STAFF REPORT SAN CLEMENTE PLANNING COMMISSION

Date: April 3, 2013

SUBJECT: Conditional Use Permit 11-507, Sign Exception Permit 11-508, Discretionary Sign Permit 11-509, Minor Conditional Use Permit 11-510, Architectural Permit 11-511, Site Plan Permit 11-512, De La Estrella Plaza (Valero), a request to consider demolition of a service station, gas station pumps, gas pump canopy, and multiple office structures to develop a new gas station with six pumps, pump canopy, car wash, convenience store with sale of beer and wine for off-site consumption, office space, off-site parking agreement, and to approve a master sign program, and freeway-oriented signs at 504 Avenida De La Estrella.

Tower

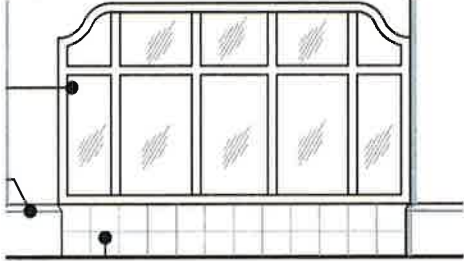
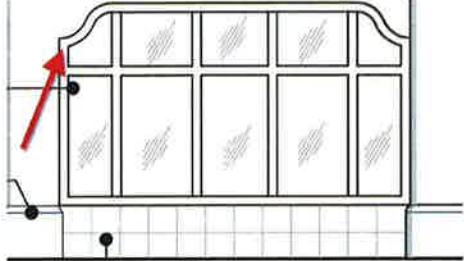
The applicant is requesting a Conditional Use Permit in order to exceed the maximum height for the zoning designation for the accent tower. The purpose of the accent tower is to provide an opportunity for additional signage both towards the community and towards the freeway.

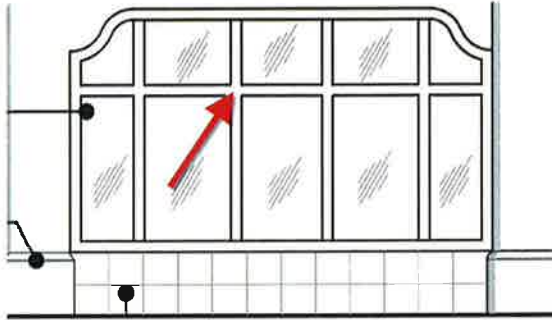
The applicant is proposing reverse channel letter internally illuminated signage which is not consistent with the architecture of the building, and staff has providing comments regarding the signage below. At a future DRSC meeting staff will provide analysis on the proposed freeway oriented signage located on the back portion of the tower, and any aesthetic impacts from the tower element itself.

Unidentified stucco feature below roof line.

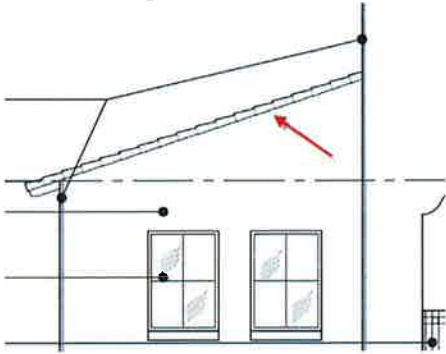
This feature needs to be identified by the applicant, and a detail needs to be provided.

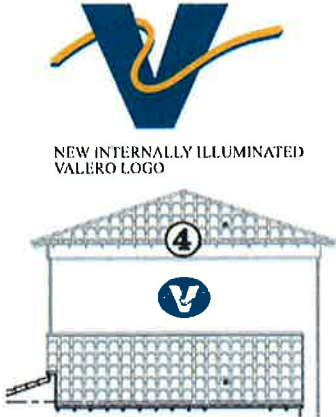
<p>Large area between the top of the second floor and the rafter tails.</p> 	<p>The massing and space may need to be reconsidered as it seems too large, or perhaps an architectural feature could be added to better utilize the space.</p>
<p>North Elevation (Facing I-5 Offramp)</p>	
<p>Undetailed parapet cap feature.</p> 	<p>Detail needs to be provided.</p> 
<p>Faux windows on tower element.</p> 	<p>Remove the faux windows as they do not serve a functional purpose. Additionally, if signage were to be approved on this portion of the tower, it would provide more space to appropriately center and locate the signage without impacting the scale of the architectural feature.</p>
<p>Diamond detail on backwall.</p> 	<p>Should be removed. Staff believes this is just a print error, but wanted to verify.</p>
<p>West Elevation</p>	
<p>Detail above door.</p> 	<p>This detail does not really add anything and is not proposed on the other doors and for consistency, staff recommends it be removed.</p>

<p>Carwash</p> <p>Cutoff roof detail.</p> 	<p>The roof should be continued to be consistent all the way across.</p>
<p>Fuel Canopy</p> <p>The canopy is a metal structure and supports, with what appears to be internally illuminated roof.</p> 	<p>Staff recommends the applicant utilize full smooth stucco columns as well as the canopy portion being smooth white stucco with a cornice or other added articulation to give it a more Spanish Colonial Revival style.</p> <p>Also staff recommends eliminating the internally illuminating around the exterior of the canopy.</p>
<p>Overall Design</p> <p>Small and un-dimensioned rafter tails.</p> 	<p>Rafter tails need to be detailed and a material provided. All rafter tails should be wood, and provide appropriate mass and scale for the roof it is supporting.</p> 
<p>No gutters and downspouts are identified.</p>	<p>The applicant needs to identify the location and materials of all gutters and downspouts.</p>

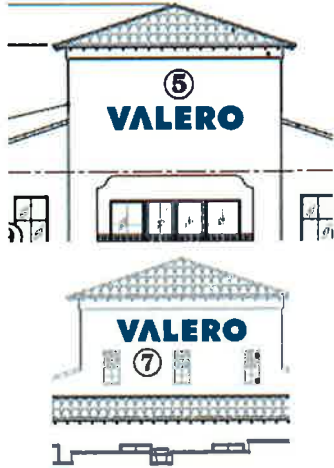
<p>Unclear if a roll over tile detail is used for the edges of the roof.</p> 	<p>The applicant needs to clearly indicate the roll over tile detail for the roof edge and should incorporate the scallop detail to provide some relief and detail in the stucco.</p> 
<p>Several faux windows proposed.</p> 	<p>All faux windows should be removed and an alternative method to break up the wall should be developed.</p>
<p>Doors are proposed with a three (3) inset.</p>	<p>Doors should have at minimum the same seven (7) inch inset as the windows.</p>

The applicant is proposing a new monument sign at the corner of Avenida Palizada and Avenida De La Estrella which includes a digital sign component for pricing. The applicant is proposing signage on the fuel canopy as well as all four sides of the new tower they have designed. Lastly, the applicant is proposing to maintain the pole sign, but has redesigned it to improve the look of the sign and added a new component which reads “City of San Clemente” with the City seal. Pursuant to the Municipal Code, the total square footage of signage permitted on the main service station site is 277 square feet, and 100 square feet on the carwash site. The applicant is proposing 366.24 square feet of signage on the main service station parcel, and 78.75 square feet of signage on the carwash parcel. The following are staff’s recommendations for signage.

) ⑦ NEW INTERNALLY ILLUMINATED VALERO LETTERS

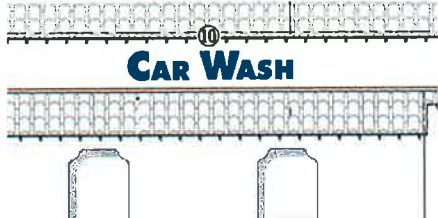
To be more in character with the architectural style of the building, utilizing a hand painted sign with decorative goose neck lighting would be more appropriate than the proposed illuminated signage.
